# UNITED STATES PATENT AND TRADEMARK OFFICE

10/628,588

<b>Office Action Summary</b>	<b>Application No.</b> 10/628,588	<b>Applicant(s)</b> DROGUE ET AL.	
	<b>Examiner</b> Michael G. Bogart	<b>Art Unit</b> 3761

## **DETAILED ACTION**

**Fig. 1**

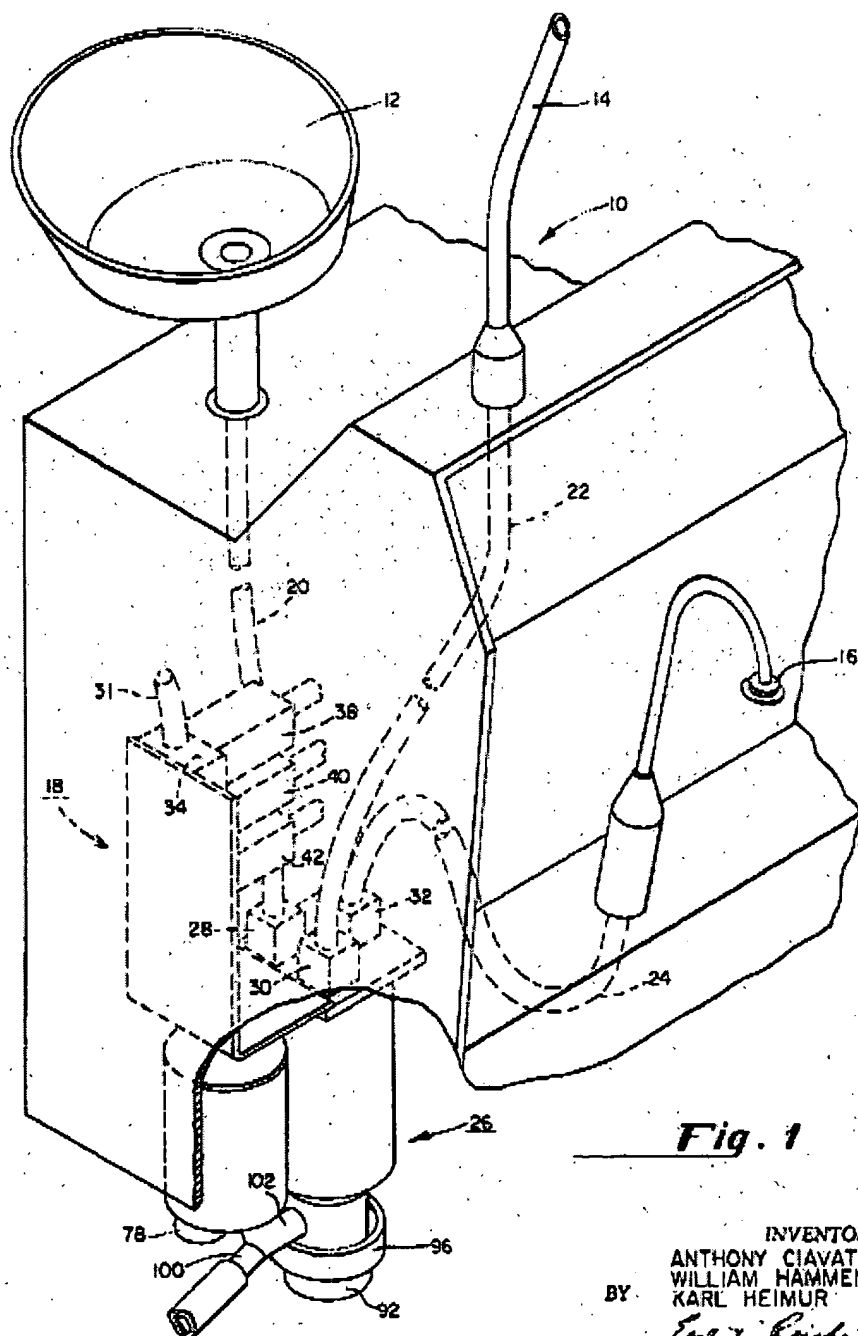
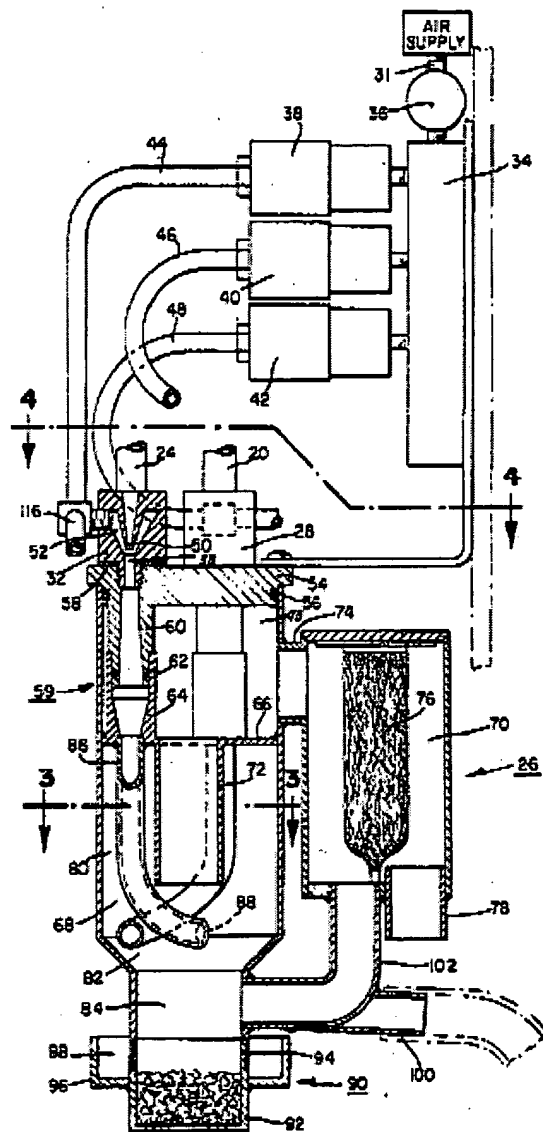
Ciavattoni teaches vacuum connector (10) located in the same room as the point of use of a vacuum tool (12, 14, 16) and capable of being connected to a vacuum source, the vacuum connector (10) comprising:

- an inlet (64);

- an outlet (84);

- a separation chamber (26, 68) in communication with the inlet (64);

- a baffle (66, 72) operably mounted in said chamber (26, 68) to cooperate with the inlet (64) capable of optimizing the separation of liquid and gaseous material;

- an exhaust air pathway (72, 73, 74, 70, 78) in fluid communication with the separation chamber (68) and the outlet (84); and

a fluid pathway (100) separate from the air pathway (72, 73, 74, 70, 78), and in communication with the separation chamber (68) and the outlet (84)(see figures 1 and 2, infra).

Regarding the rejections under 35 USC § 103, applicants assert that Chiavattoni does not disclose an air pathway in communication with the separation chamber and outlet and a fluid pathway separate from the air pathway, and in communication with the separation chamber and the outlet. This argument is not persuasive because Ciavattoni discloses an exhaust air pathway (72, 73, 74, 70, 78) in communication with the separation chamber (68) and outlet (84) and a fluid pathway (84, 100) separate from the air pathway (72, 73, 74, 70, 78), and in communication with the separation chamber (68) and the outlet (84)(see figure 2, supra). Both the discharge line (100) and exhaust airway (72, 73, 74, 70, 78) are in fluid communication with outlet (84) as there no physical structure preventing fluid from passing between these elements. Also, exhaust fluid (air) is vented from outlet (84) to exhaust chamber (70) via vent (102).

FIG. 2

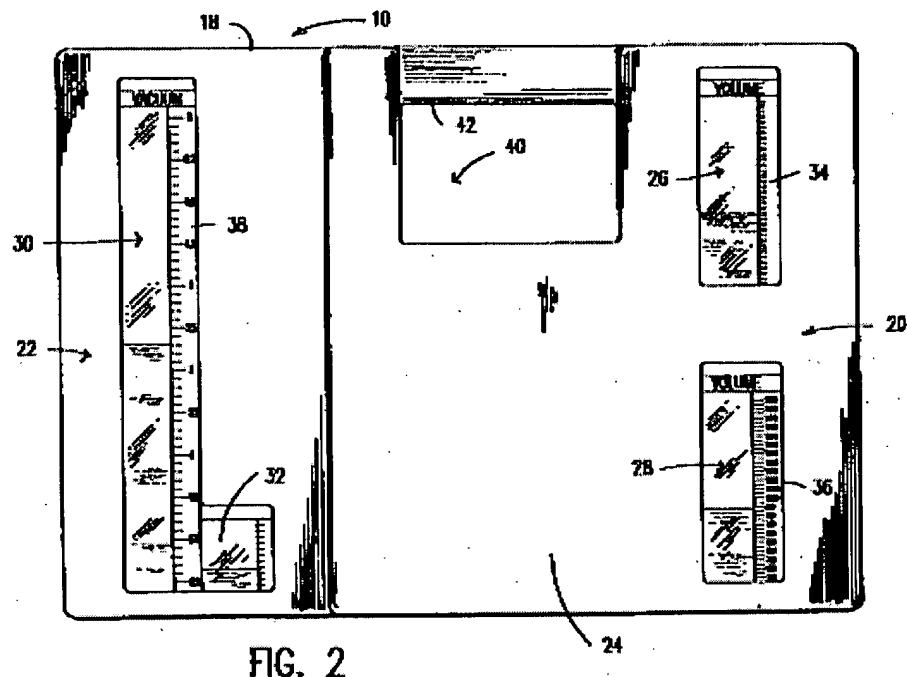
Goosen teaches a flow volumetric flow indicator (26)(figure 2, infra).

At the time of the invention, it would have been obvious to one of ordinary skill in the art to add the flow indicator of Goosen to the evacuation apparatus of Ciavattoni in order to provide a means of monitoring the flow rate of the system.

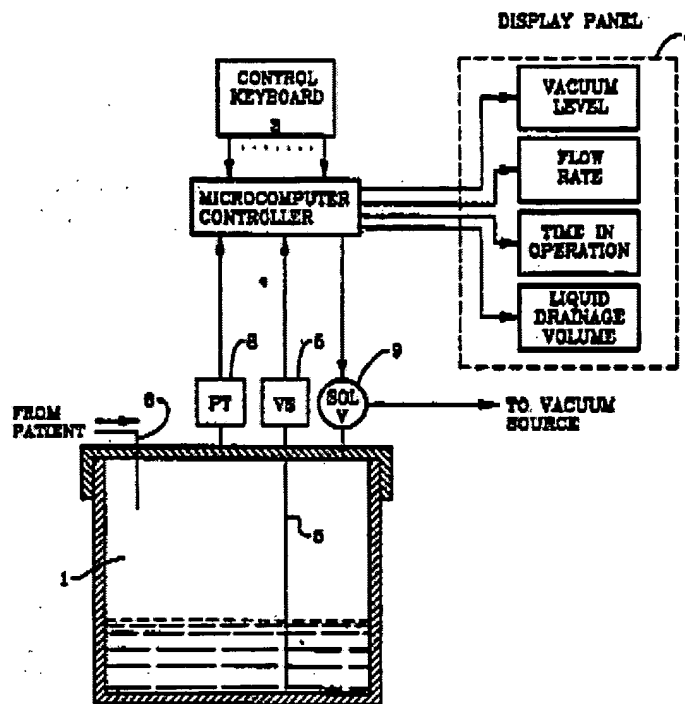
Walker teaches a keyboard (3) for controlling a medical suction apparatus (see figure 1, *infra*).

At the time of the invention, it would have been obvious for one of ordinary skill in the art to add the keyboard of Walker to the evacuation apparatus of Ciavattoni in view of Goosen in order to provide a means of controlling the air pressure and vacuum applied to a patient.
